State of New Mexico
 Energy, Minerals and Natural Resources

Form C-103
 Revised July 18, 2013

Colgate Operating, LLC respectfully requests to P&A this well. Please see attached procedure, current WBD and proposed WBD.

Exxon State #2 – P&A Procedure**AFE: 500808****Objective:**

Permian Resources - Proposed WBD

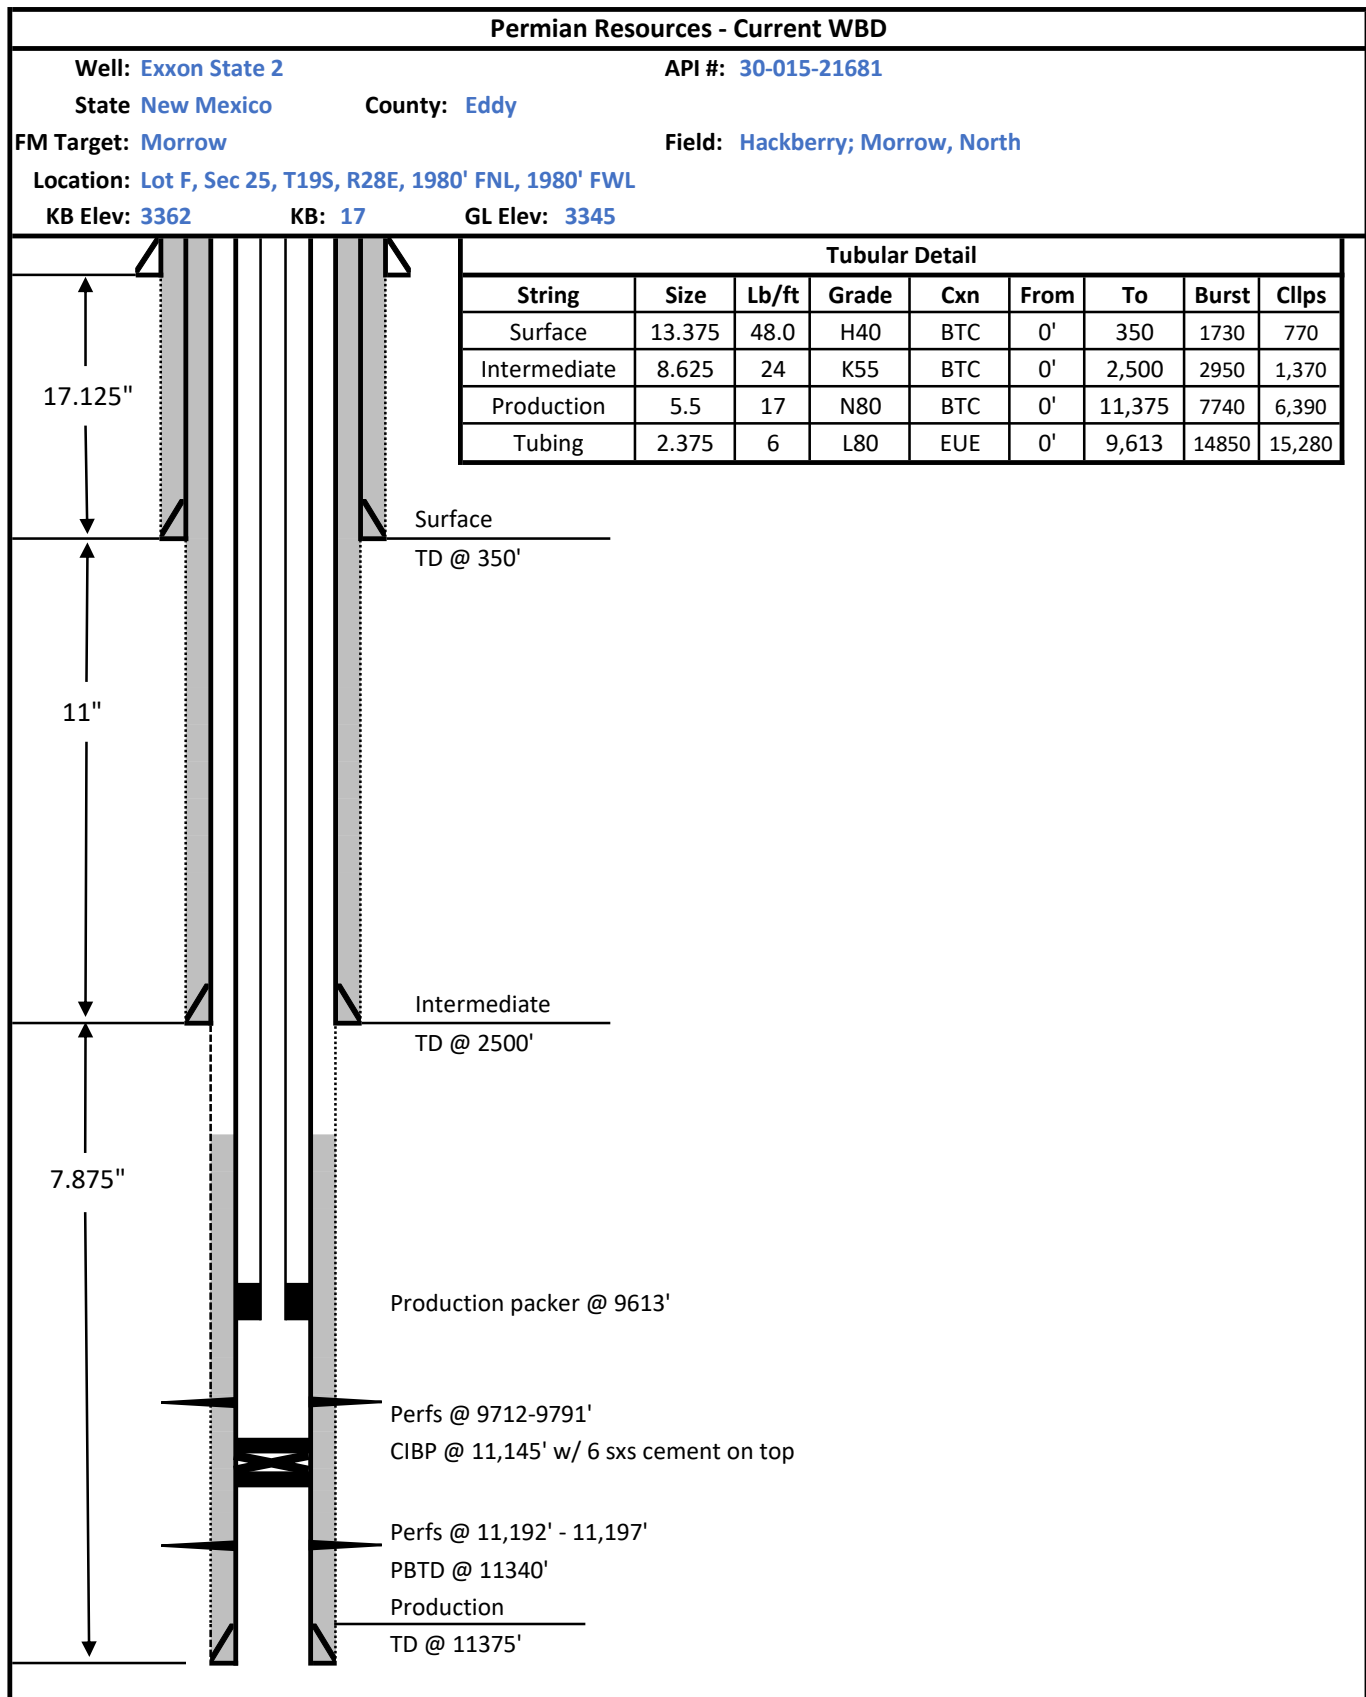
Add plugs:

Wolfcamp Top @ 8929'

BS Top @ 4050'

Delaware Top @ 3146'

Run CBL to confirm TOC,
plugs set with no cmt
behind pipe require perf &
sqz

Perf & sqz all csg shoes,
Best practice to perf & sqz
surf csg @ 350' & circ cmt
to all strings to surface.

See proposed
WBD for plugging
revisions. P&A
approved for 1yr.
